HISTORIC DISTRICT COMMISSION ADDITIONAL INFORMATION REQUEST

Application Number: HDC2026-00252

NAME: Tanya Contreras		COMPANY NAME: N/A	
ADDRESS: 3010 Tyler Street	CITY: Detroit	STATE: MI	ZIP: 48238
PROJECT ADDRESS: 4254 Tyler St.			
HISTORIC DISTRICT: Russell Woods-Sullivan

WINDOWS:

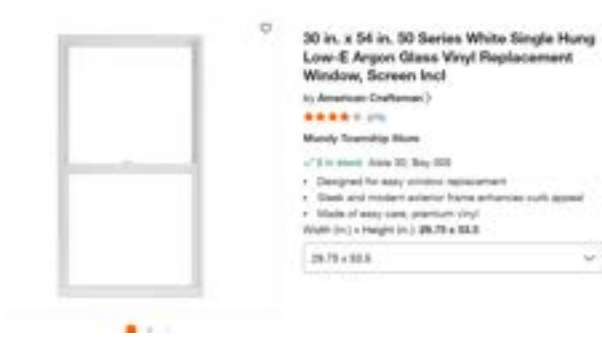
WINDOWS • Written description of how the existing historic wood windows are to be restored • Numbered window schedule for the new windows, which includes... - Visual depiction to show the proportions, material, color, operation, lite configuration type and dimensions, and dimensions of each proposed new window (this is often provided with window orders, quotes, etc.) • Photos of the exterior elevations of the house (we need to see the whole sides, not close up photos, please) with labels to coordinate with the numbered window schedule • Interior photos of each of the existing historic windows proposed to be replaced (we need to see the whole window, with proper lighting) with labels to coordinate with the numbered window schedule • Clarify if the window's frames, trim, sills, lintels, mullions, and/or brick mould will be kept in place, removed, or covered, and how

The existing historic wood windows at the property are currently in deteriorated condition due to prolonged exposure, deferred maintenance, and water intrusion. Several windows show signs of rot, damaged glazing, broken panes, failing sash components, and deterioration of surrounding trim and framing materials. Some openings are no longer weather-tight and are contributing to additional moisture intrusion into the structure. All are covered with plexi-glass.

New vinyl windows with grid will be installed in the front side of the house, and single hung windows in the rear and back of the house where needed within the existing openings without altering the original architectural rhythm of the façade. Singular window in the rear right of the house will be restored.

The project proposes maintaining the existing window locations and preserving surrounding architectural details wherever possible, including existing trim and masonry openings. Any damaged sill or framing components requiring replacement will be repaired. Wooden shutters will also be added to match the current/missing ones.

ID #	Proposed Location	Quantity	Dimensions (W×H)
W01	Front	1	32" by 60"
W02	Front / Sides	11	30 y 54"
W03	Rear	2	26" by 52"
W04	Side / Rear	1	24" by 42"
W05	Rear	2	28" by 38"

PROPOSED:

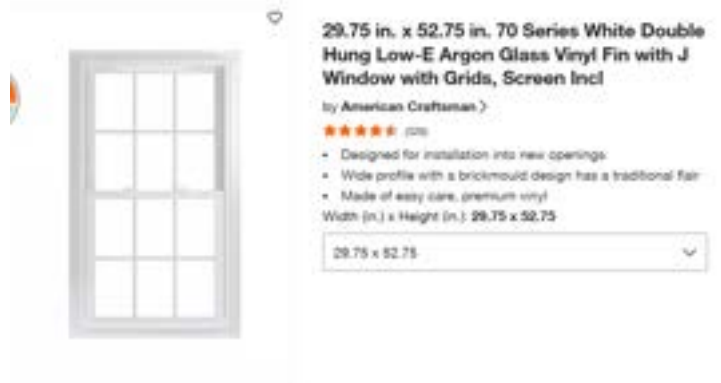
PLEASE NOTE: the installation of vinyl windows does not fall within staff authority to approve and will require review by the Historic District Commission ("the Commission") at an upcoming meeting. The Commission regularly does not approve vinyl windows as its installation is not appropriate for the historic character of the house.

REAR/BACK WINDOWS

FRONT WINDOWS
